Alabama State Port Authority
Addendum to R&P or Specification Booklet

Project Name Pit and Roof Extension TASD Diesel Shop

Project No. 11407 **Task No.** 02 **Addendum No.** 2

The following items are clarifications to questions received. These items are hereby included in the bid documents by this addendum.

4503-C1

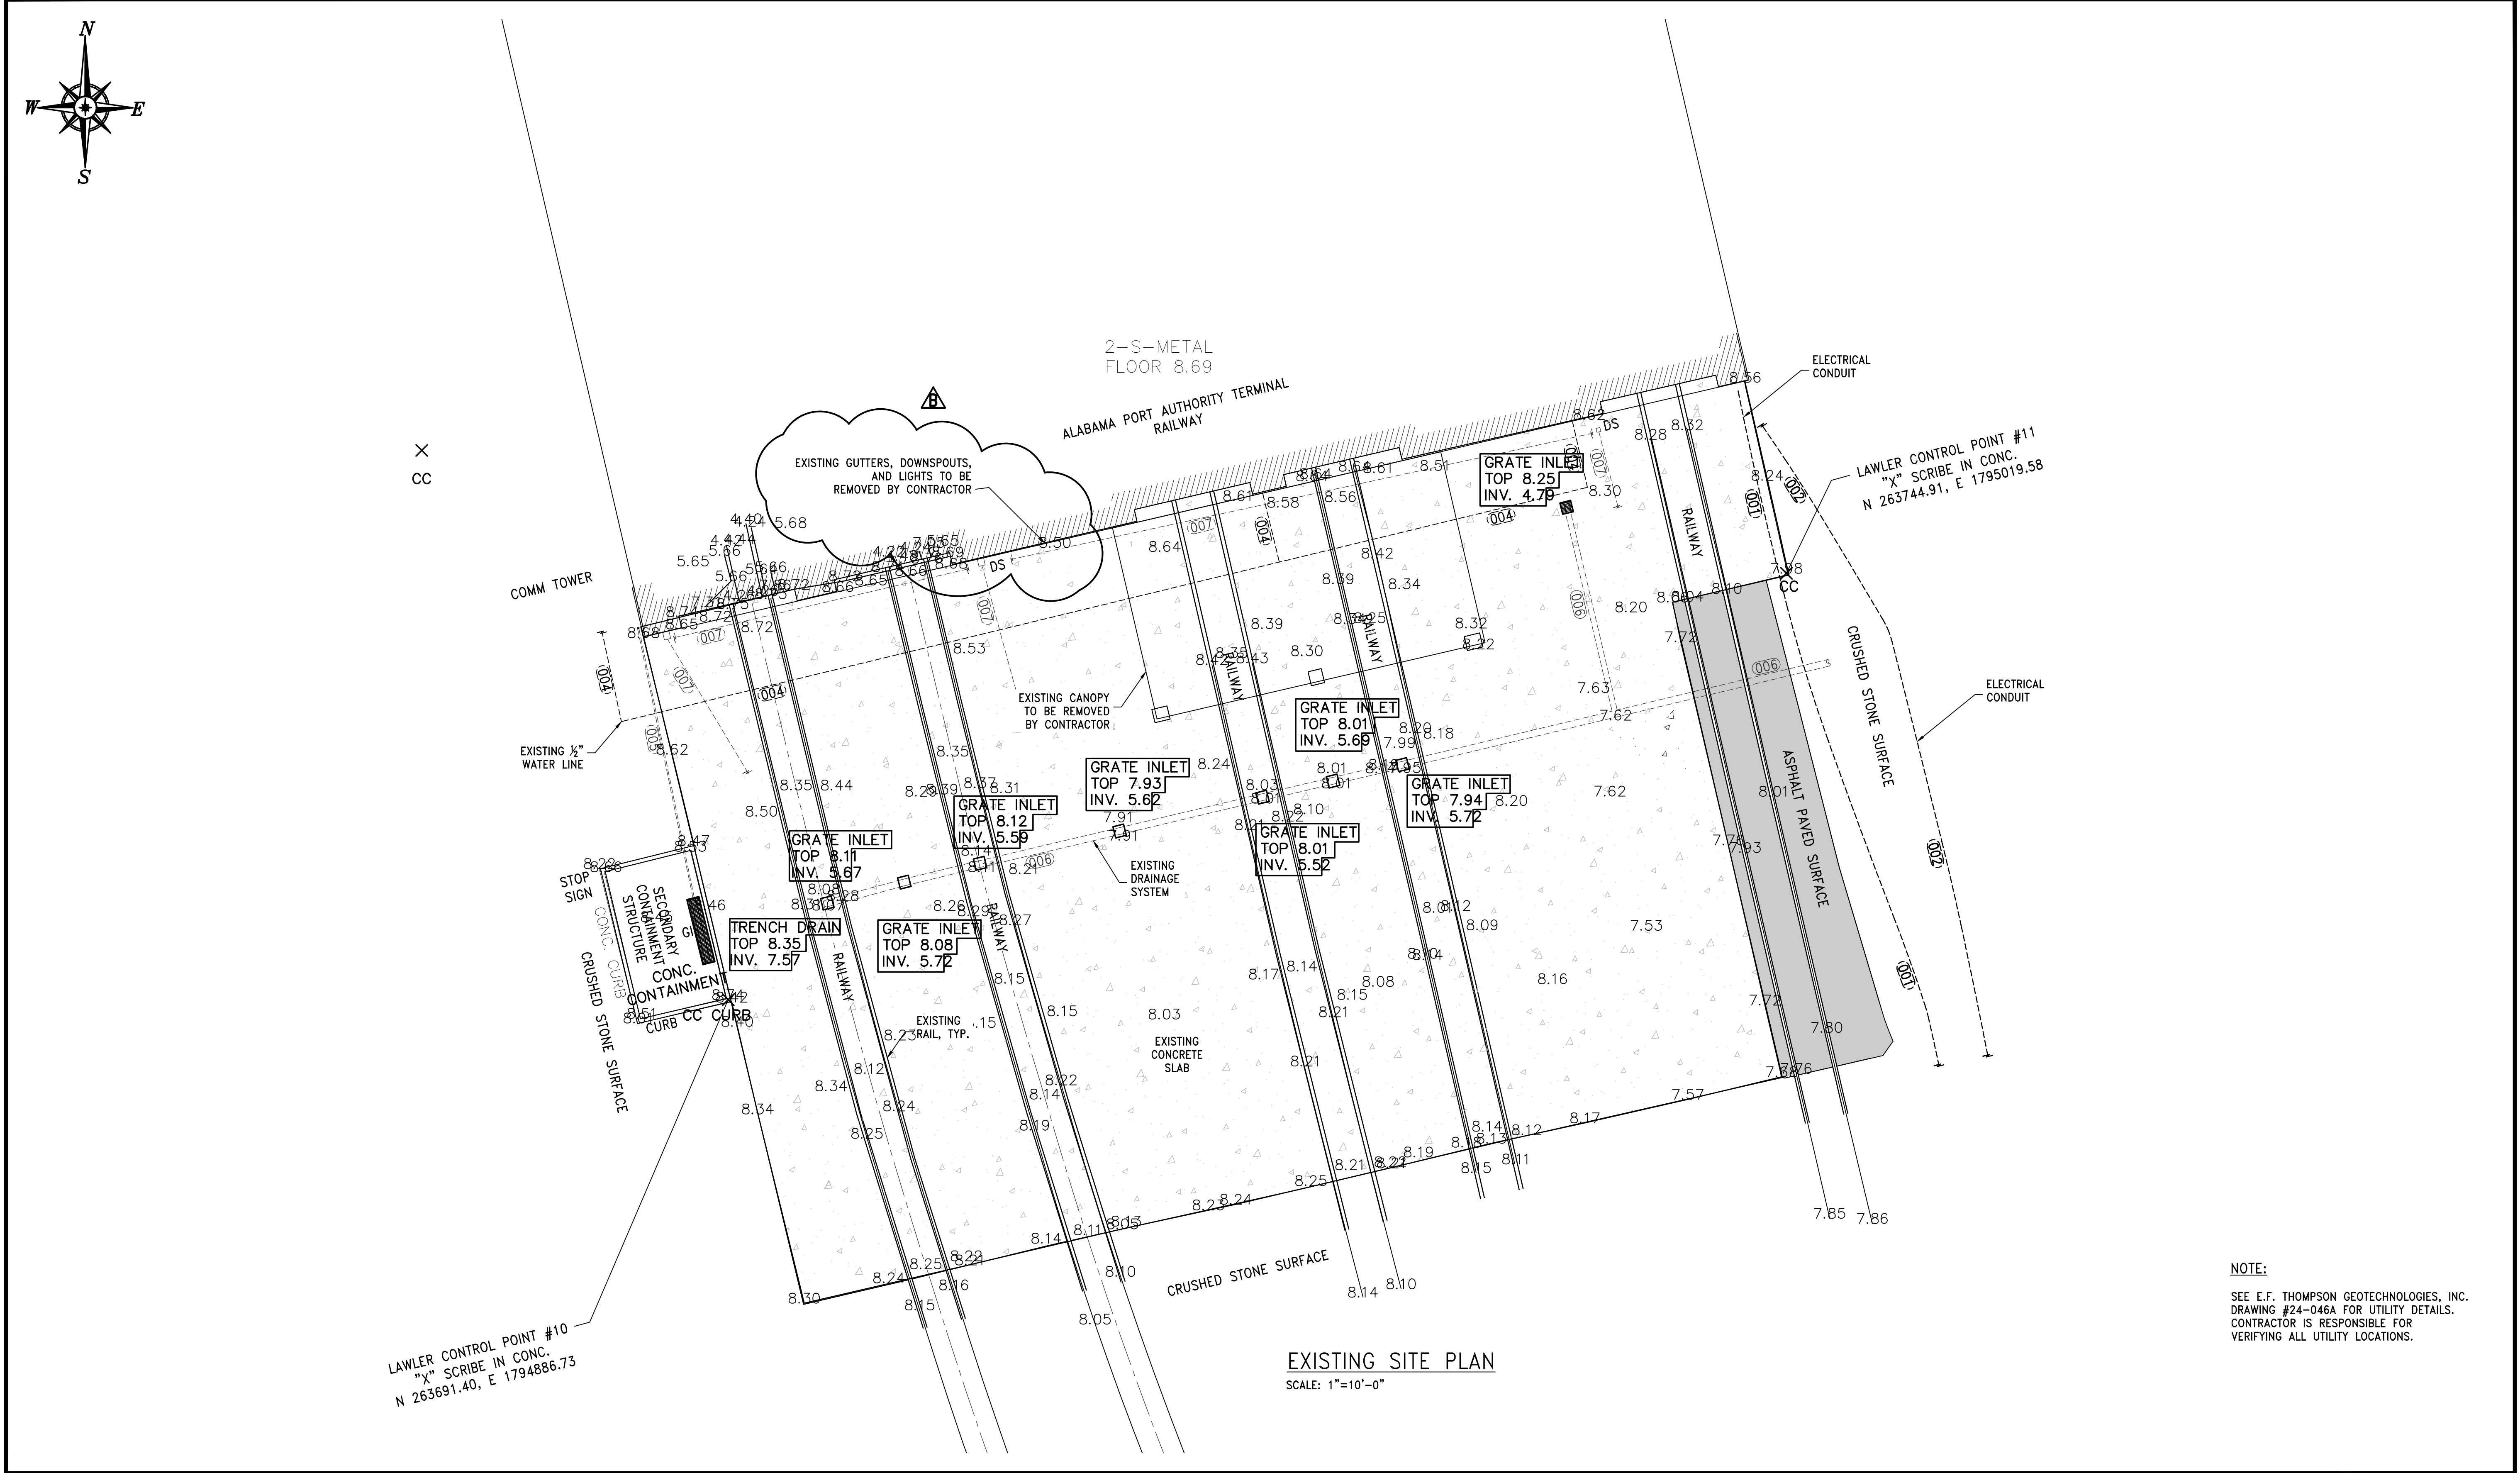
Item	Description
1.	<p>Question: Is there a geotechnical report? If so, could you please send it over so we can review the soil conditions on the site?</p> <p>Answer: Yes, the Geotech report will be provided to all prospective bidders.</p>
2.	<p>Question: Is there a confirmed working grade?</p> <p>Answer: See revised 4503-C1.</p>
3.	<p>Question: What is Top of Cap elevation for all the isolated one and two pile caps?</p> <p>Answer: Top of Cap elevation for A1, A2 and A3 is 5.6. Top of Cap elevation for all remaining caps is 8.6.</p>
4.	<p>Question: To your knowledge, are there any horizontal or vertical proximity issues that would affect a drilling rig? We typically need at least 5' of clearance horizontally and no restrictions vertically.</p> <p>Answer: See clip below. Column line A is 2'-3-1/2" from the centerline of the pile to the edge of the existing building.</p>

C	ADDENDUM 2 - REVISED SPOT ELEVATIONS	05/01/25	VTH	WBS
B	ADDENDUM 1	04/22/25	VTH	WBS
A	ISSUED FOR BID	04/04/25	VTH	WBS
REV.	DESCRIPTION	DATE	BY	CHK'D
